Reviewer comments, first round review –

Response to Reviewers' Comments on “Cost Increase in the Electricity Supply to Achieve Carbon Neutrality in China”

Figure 5: Annual carbon reduction trajectory under each scenario

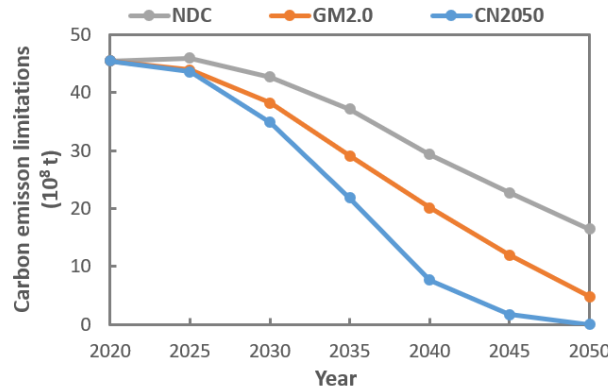
Comment 2: Your work supports the claims and conclusions you present but some assumptions like carbon reduction trajectory might be better if expressed explicitly in the body of the paper.

Reply: Thank you for your insightful comments. The annual carbon emission limit trajectories are presented in Fig. 5. The setting of annual carbon emission limit trajectories under different scenarios refers to the report from the Institute of Climate Change and Sustainable Development[22]. There is no carbon emission limit for the BAU scenario, so it is not shown in 5. We have put the figure in the body of the paper. We also added some other necessary assumptions in the text of the main paper. Please see the “Model and scenarios” section in the revised paper for details.
